**Year One Monitoring Report**

**GROUNDHOG HOLLOW PROJECT**

RE: Groundhog: Year 1 Monitoring Report (NCDMS ID 100049)

Listed below are comments provided by DMS on January 18, 2022 regarding the Groundhog Mitigation Site: Year 1 Report and RES' responses highlighted in blue.

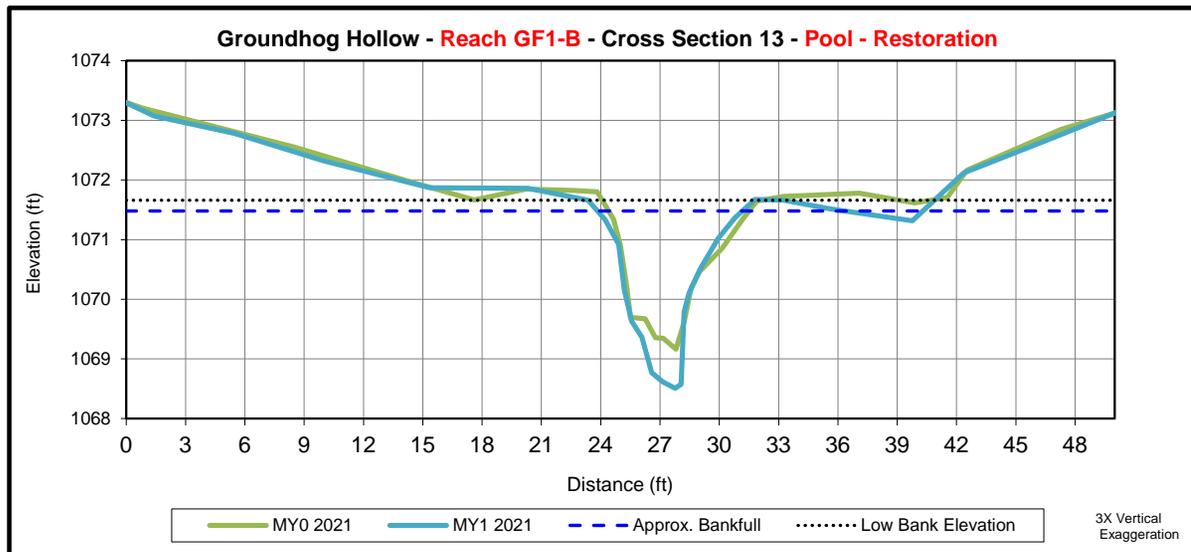
**Appendix D – Cross Section 12:** The footnotes for this cross section are misaligned in the draft received. Please correct.

Done.

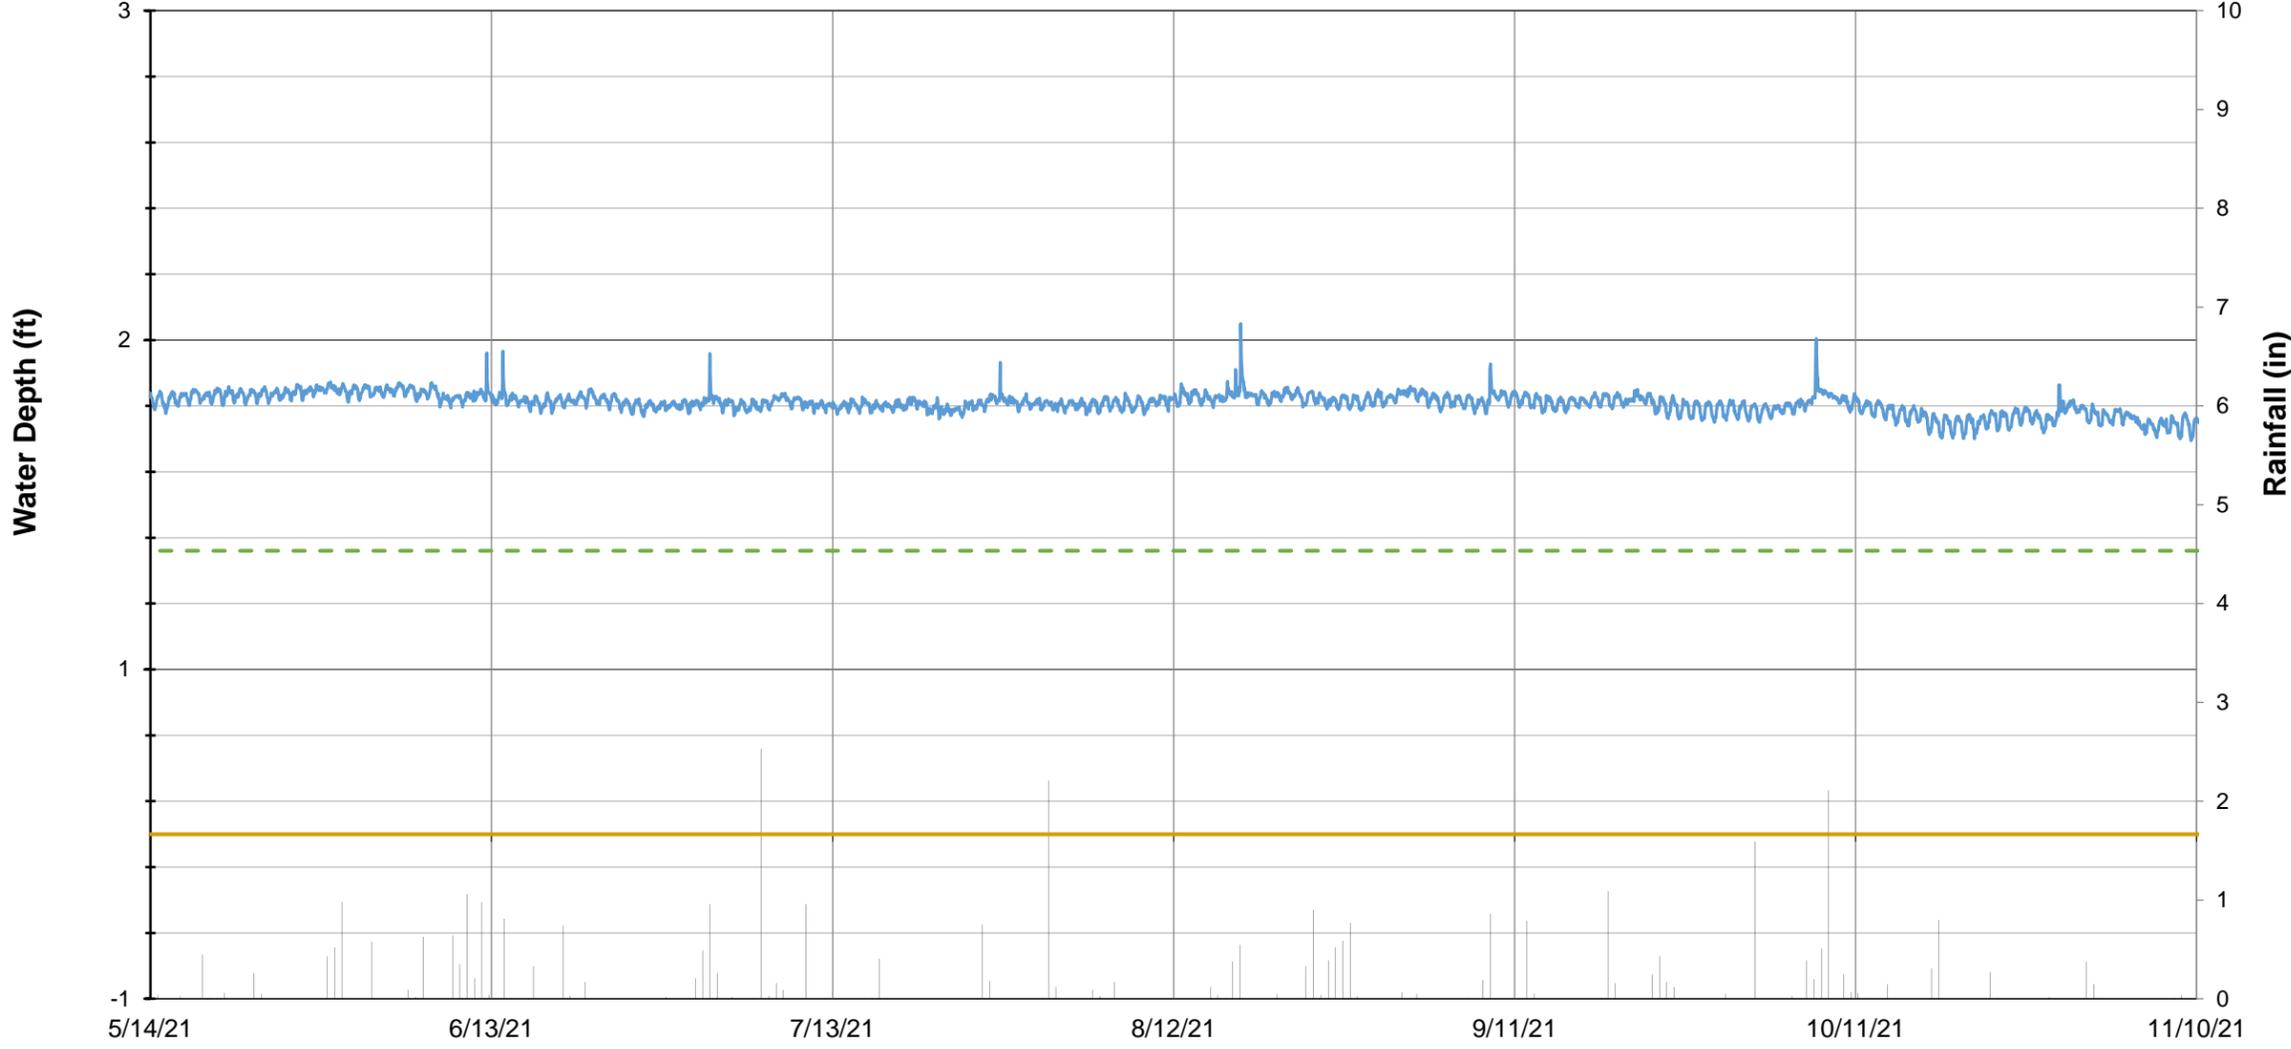
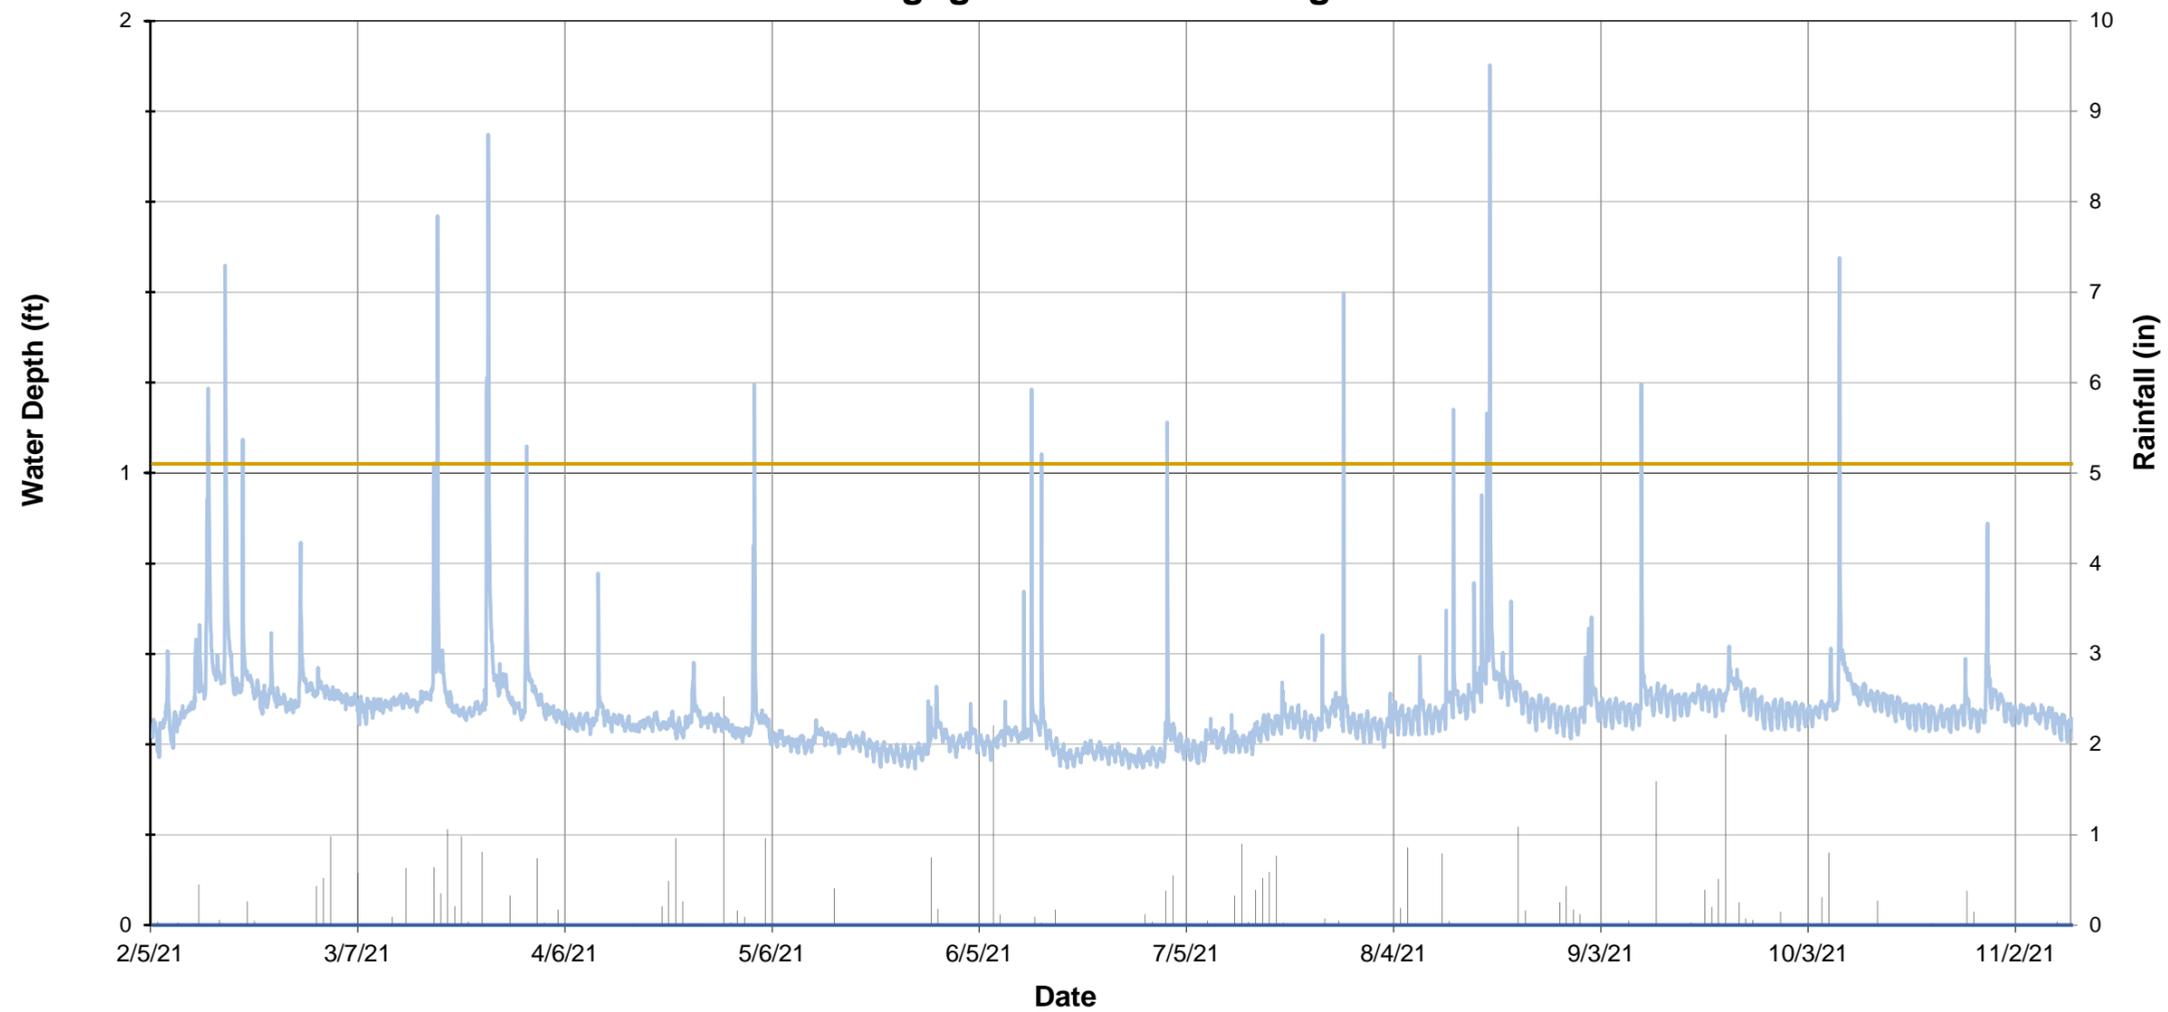
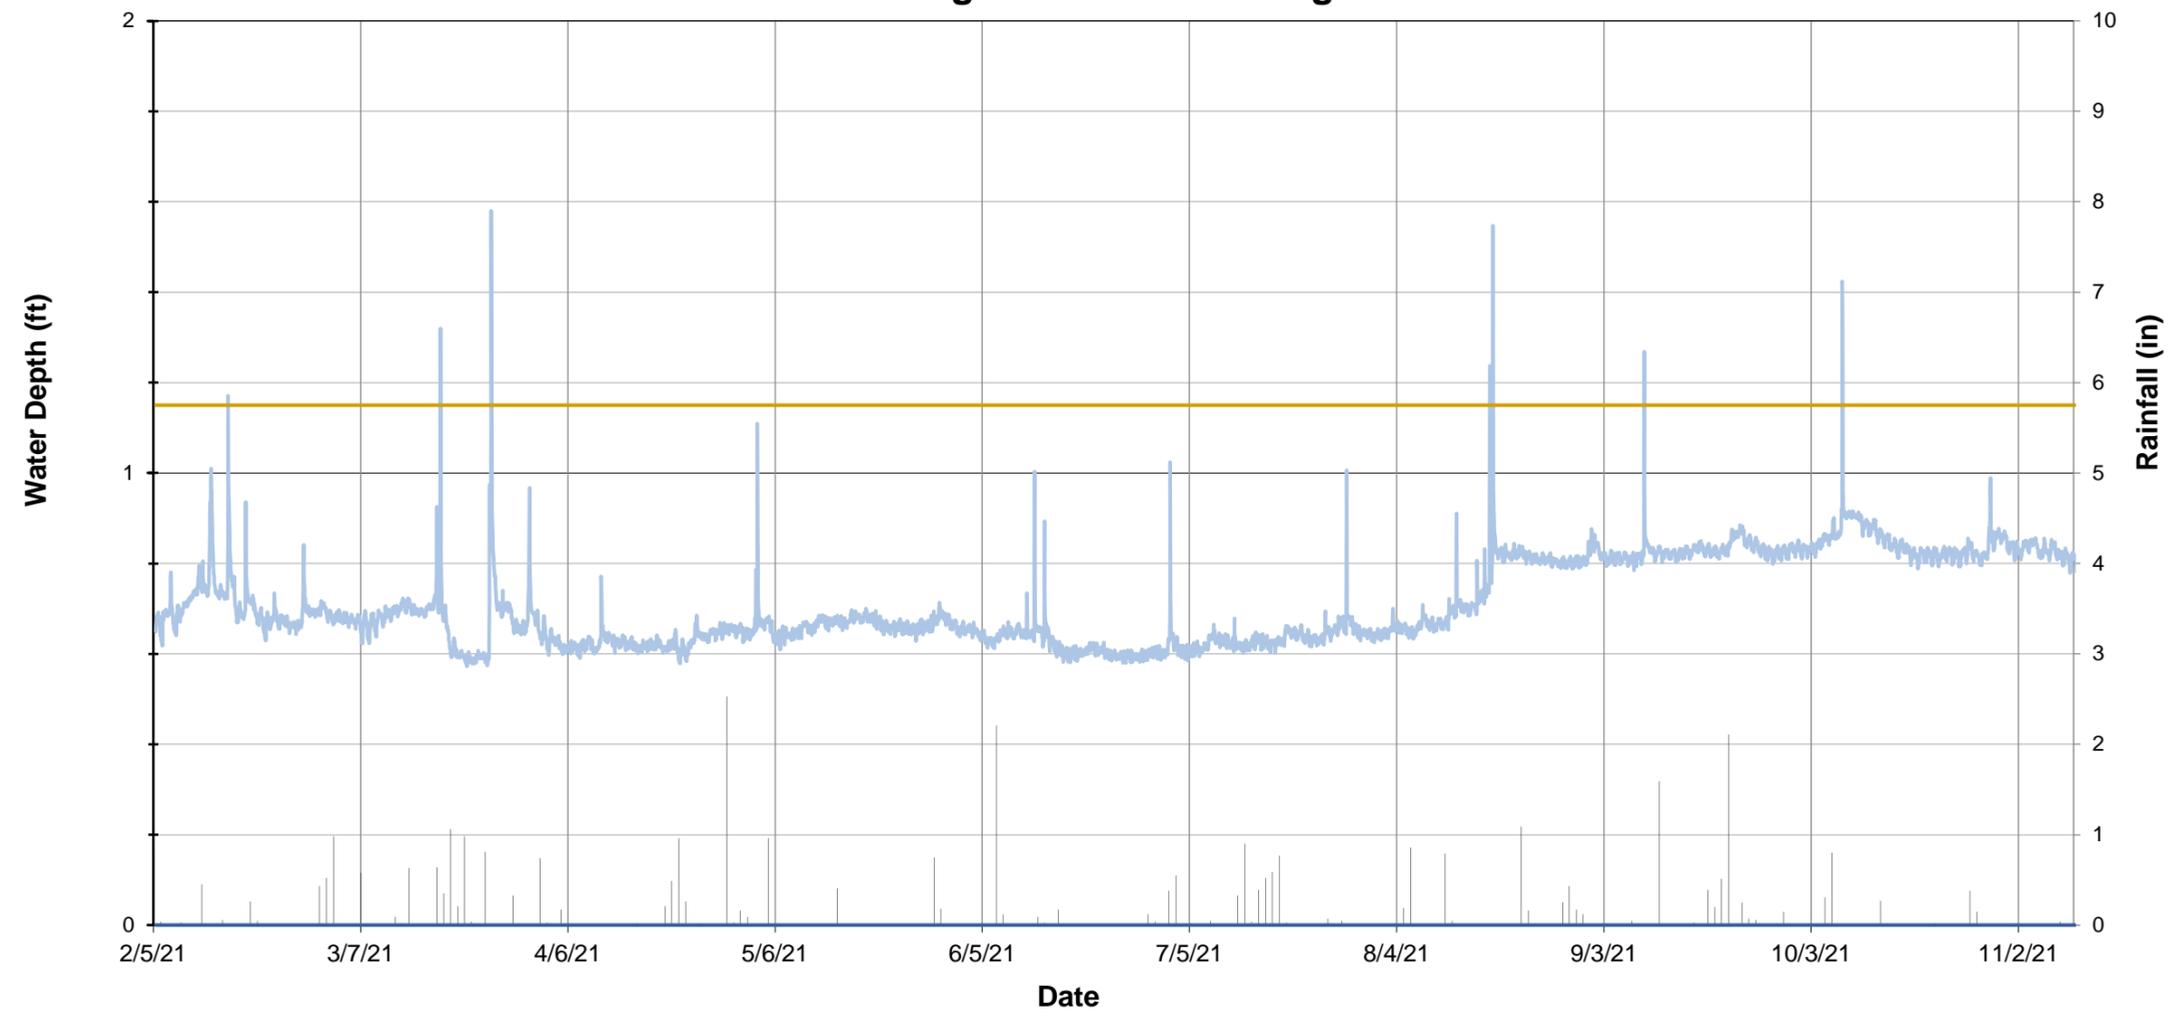
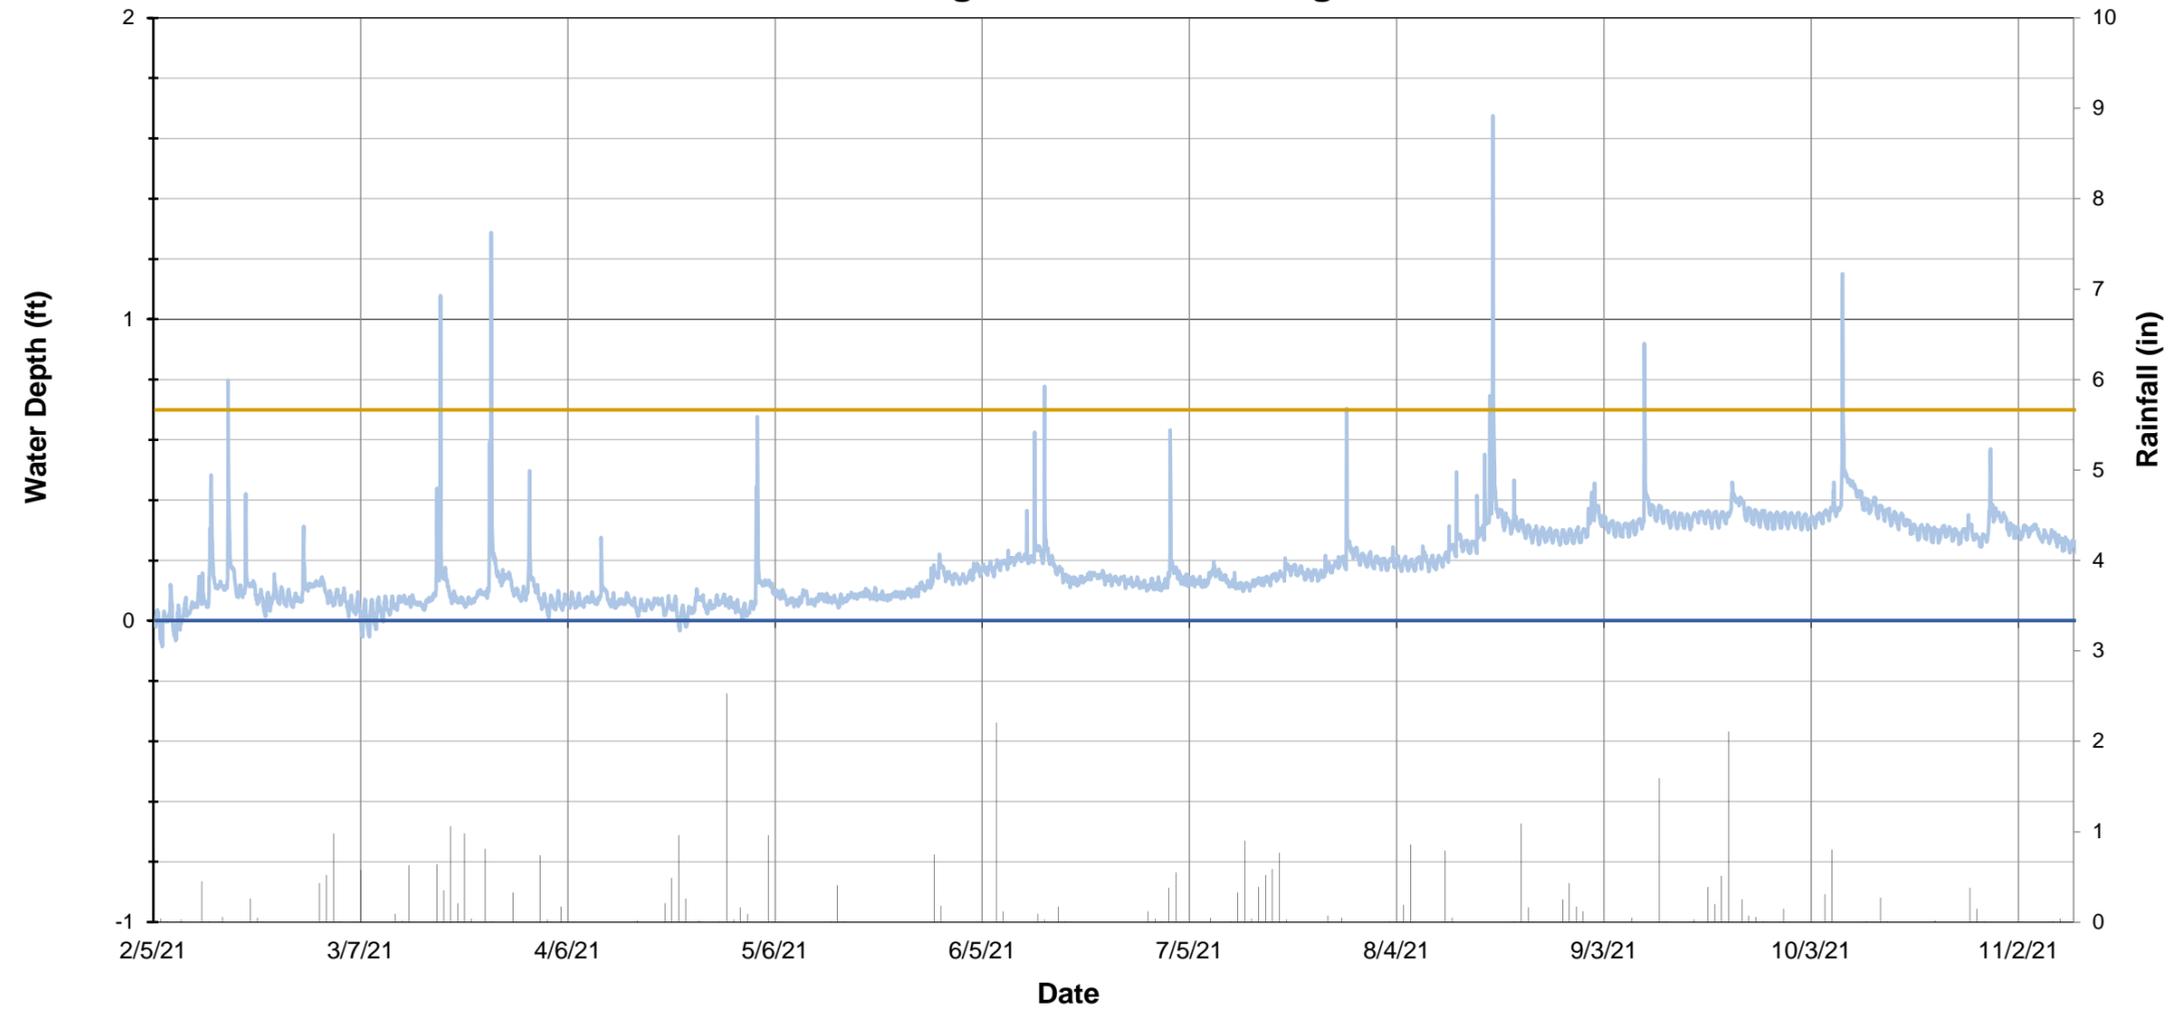
**Appendix E:** Please provide graphs to substantiate the bankfull events reported in the text.  
[Done.](#)
